The ISO received comments on the topics discussed at the September 20 & 21, 2018 stakeholder meeting from the following:

The following are the ISO’s responses to the comments.

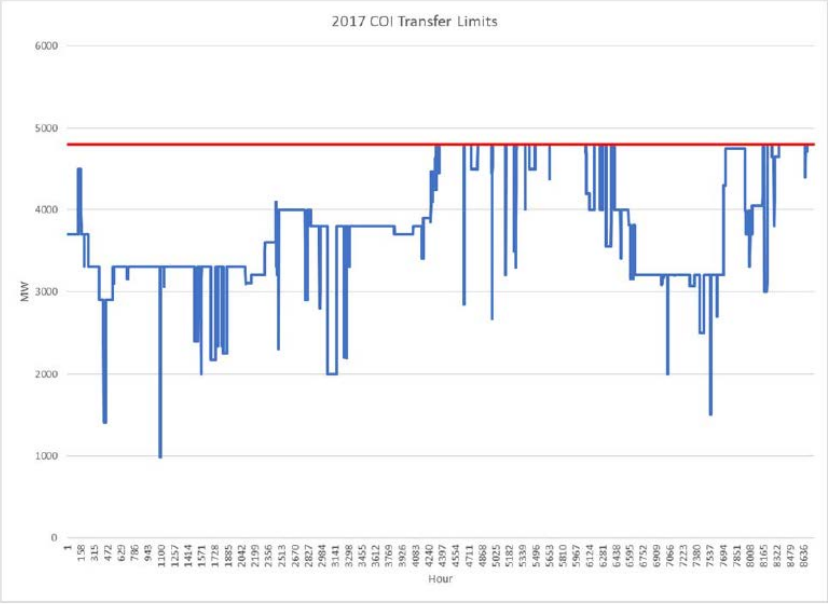
No	Comment Submitted	CAISO Response
14a	<p>Silicon Valley Power (SVP) is a municipal electric utility owned and operated by the City of Santa Clara. Our customer composition is over 90% industrial and only 6.6% residential. While our future residential consumption is forecast to be generally flat, SVP has recently experienced a strong interest from new, high load factor, data center projects. We expect these new customers to raise SVP's load factor from the current low 80% range to the upper 80% range. Some of these new loads are already on-line and others are in various stages of development. Our experience has been that these data center loads materialize quickly. As such, SVP has an internal capital plan to expand its internal system to connect these new customers. We understand that the PG&E service area in the South Bay is also receiving requests for interconnection of some data centers.</p> <p>SVP's load forecasts are reviewed by the CEC and are included in the new 2018-2019 TPP series base cases. The impacts on the transmission system in San Francisco Bay Area, and especially the San Jose Division, are beginning to appear in the CAISO's Preliminary Transmission Assessment results. Fortunately, there are few issues in the near-term 2020 case. However, by the mid-term 2023 case, loading issues on the 115 kV circuits south of Newark appear. Additionally, the NRS-SRS 115 kV circuits, which are currently being reconnected, will again become overloaded. Furthermore, we understand that the assessment actually dispatched a major local resource, the ~300 MW NQC Los Esteros Critical Energy Facility (LECEF), off-line during a summer 1-in-10 load condition to reduce other 115 kV transmission contingency loadings. Then by the long-term 2028 case, many of the local 115 kV circuits are seeing overloads in the 30% to 60% range.</p> <p>Also linked to the load growth in the South Bay, the CAISO long-term Local Capacity Requirement (LCR) studies are showing an increase in the Greater Bay Area LCR of almost 2,200 MW in the 2028 study compared to the previous 2023 study. The San Jose sub-area shows a 204 MW deficit due to the loading of the same 115 kV circuits south of Newark. This increase in the Greater Bay Area LCR reduces the margin between the Total Generation and the LCR need</p>	<p>The ISO encourage SVP to participate in the CEC's demand forecast process and make sure that the CEC's forecast accurately captures future demand growth in the SVP area.</p> <p>In regards to the reliability concerns identified in this cycle, the ISO will closely monitor the load increase in future CEC demand forecast and will also coordinate discussion with parties for potential mitigation development.</p>

No	Comment Submitted	CAISO Response
	<p>to 275 MW, or less than the NQC of the LECEF that is being dispatched off-line in some of the assessment analyses.</p> <p>While SVP understands that this new projected loading is a significant increase from prior year's assessments, we are concerned that the identified mitigation is simply to "Continue to monitor future load forecast." The South Bay is a highly-developed area within a CAISO high density urban area, where the timeline to expand the electric transmission infrastructure can be very lengthy. Such a wait-and-see approach risks local capacity constraints that could either restrict economic development, reduce system reliability, or both. While it may be premature to approve a specific capacity expansion project without further planning studies, those studies should be initiated in parallel with monitoring the future load forecasts. Once a plan has been developed, critical lead times and decision points can be identified.</p> <p>In closing, SVP appreciates the inclusion of the higher forecast loads in the 2018-2019 TPP base cases so that these potential transmission capacity limitations can be identified. We encourage all parties to recognize the need for a long-term transmission plan for the South Bay that can accommodate the current and future economic development.</p>
